Making the Right Call in Sisseton

Mark Malone, PE
SD DOT

Why are we here again?

Veterans Ave

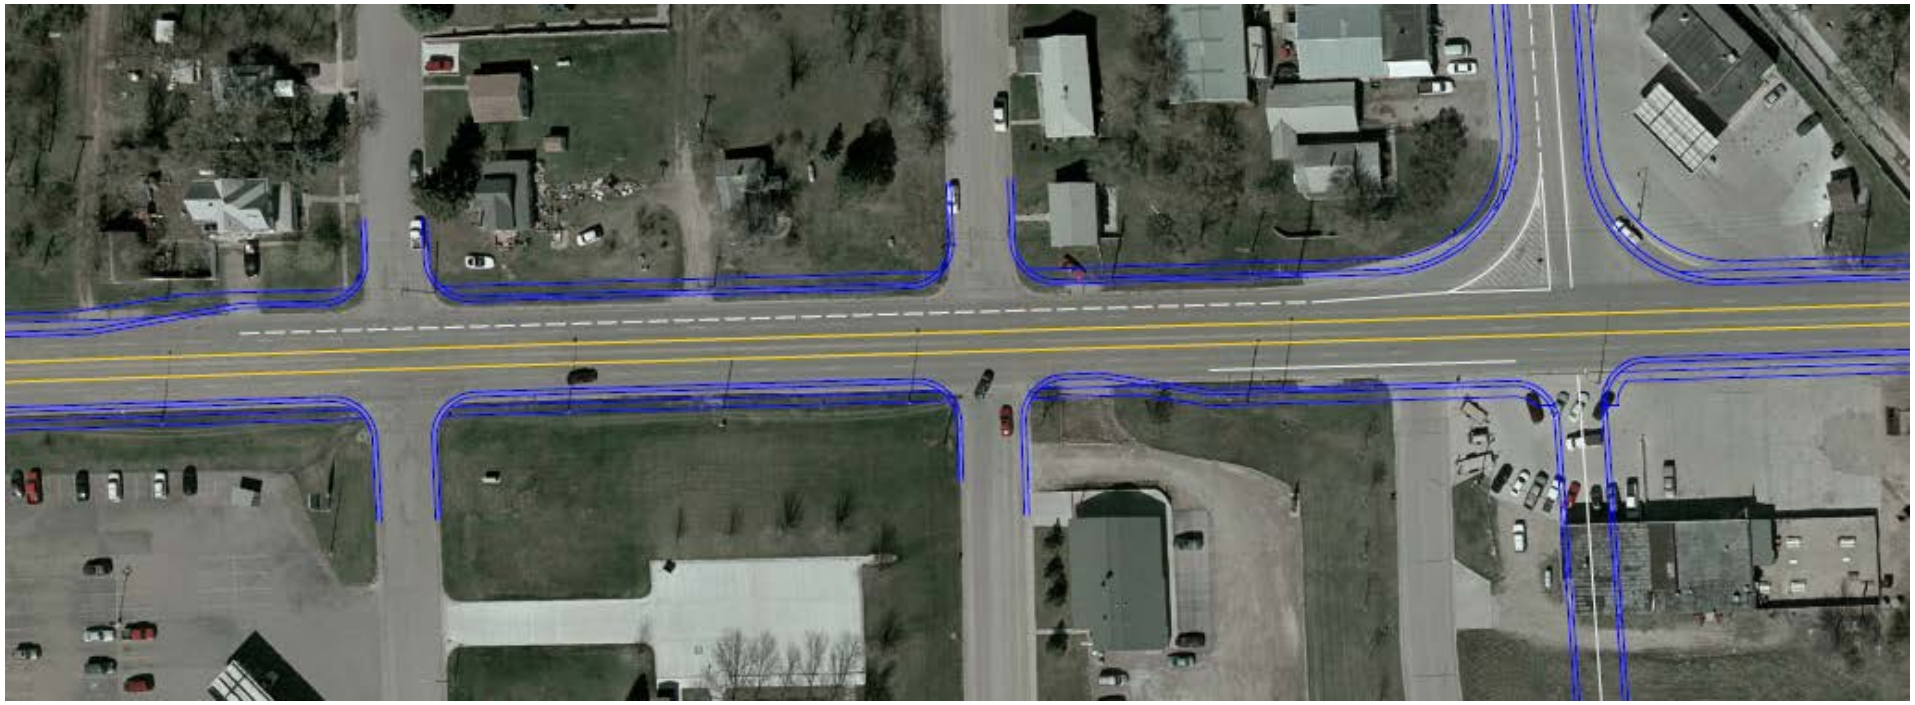
- Veterans Ave area
  - Hill to west of Veterans Ave
  - Coteau Blvd turn lane for hospital entrance
  - Intersection warrants a signal
  - Conflicting left turns

- Coteau realigned
- Right turn lane to Coteau
- Added lane to go up the hill from Veterans Ave

8th Ave E

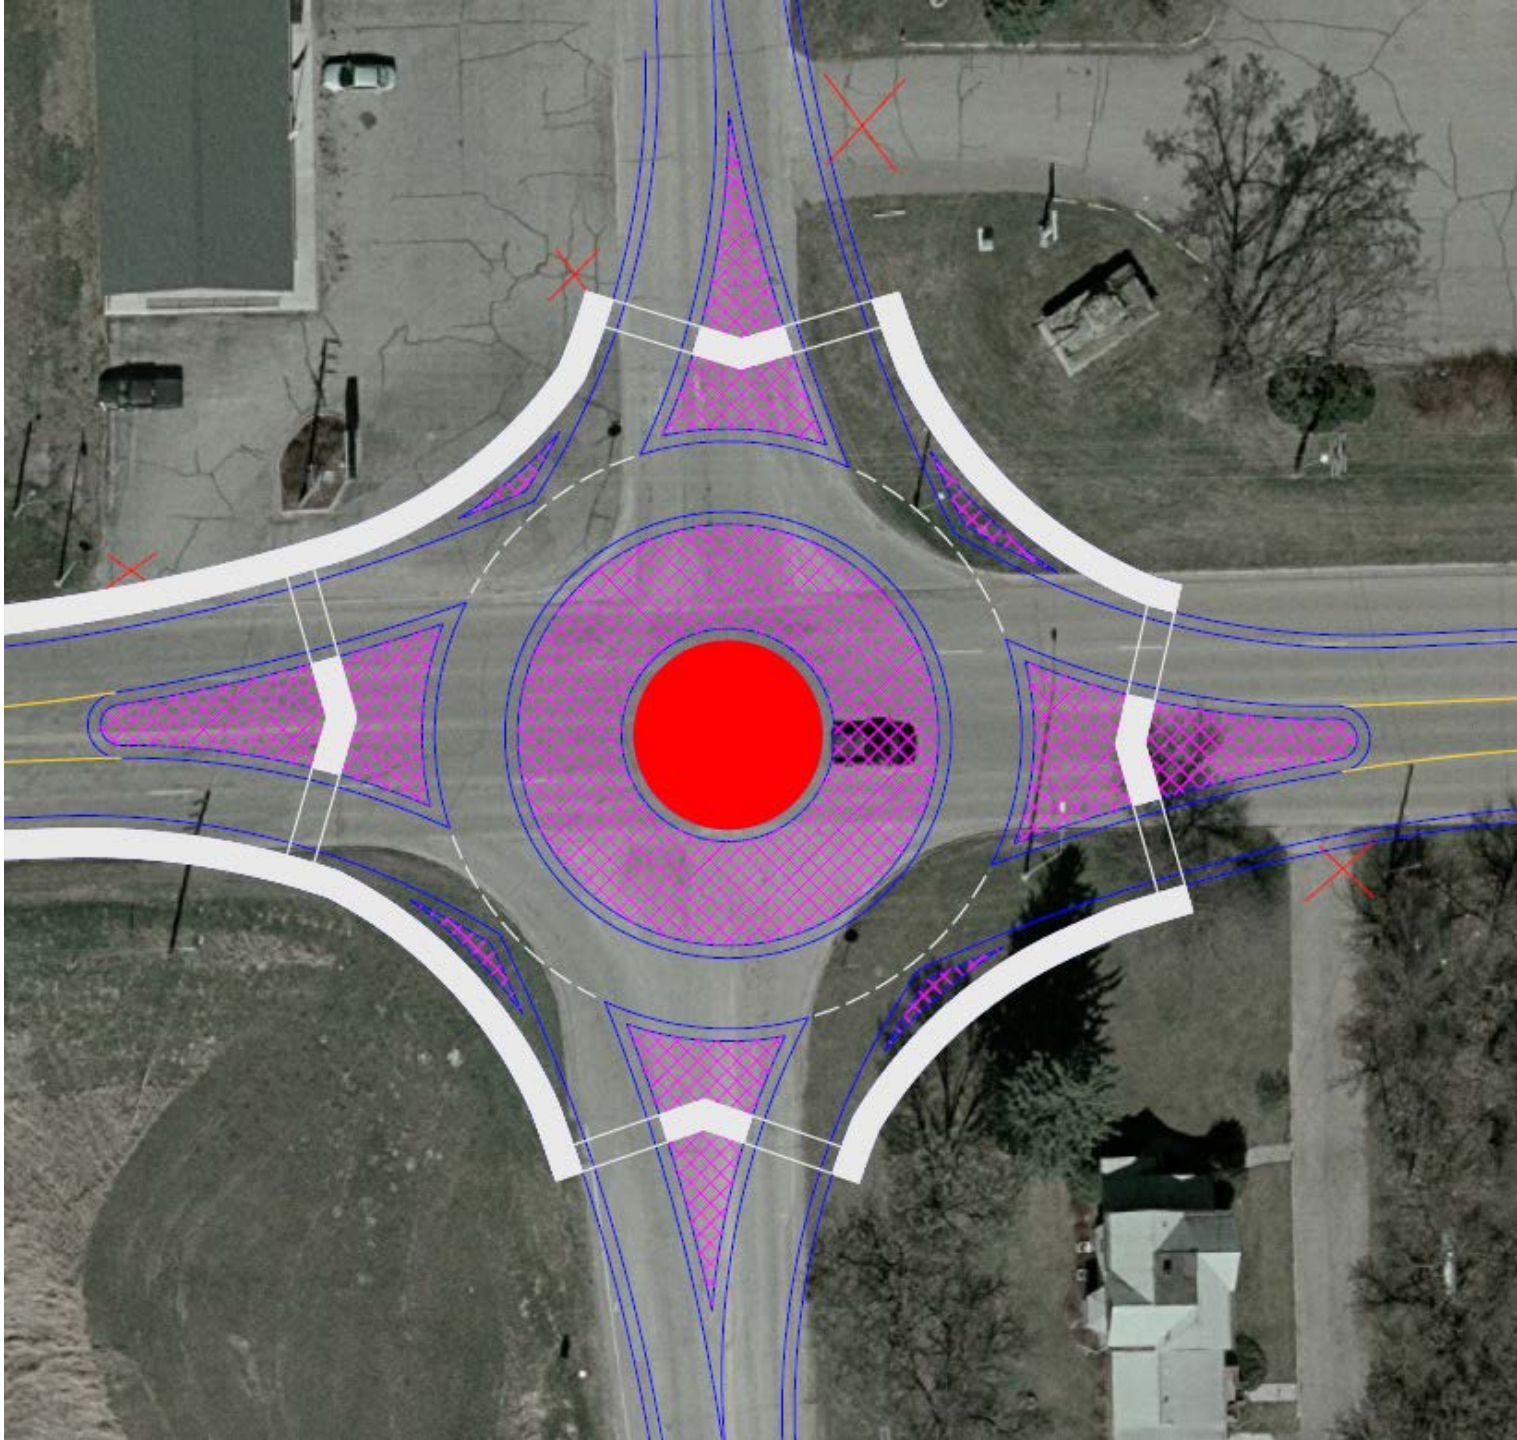
Traffic Needs – 8th Ave E & 8th Ave W

- Traffic Counts warrant a controlled intersection
  - Roundabout
    - ✓Meets traffic demands
  - Signal
    - ✓Meets traffic demands
  - 4 way stop
    - ❖Does not meet traffic demands
  - 2 way stop (as currently exists)
    - ❖Does not meet traffic demands

- Roundabouts
  - 8th Ave E
  - 8th Ave W
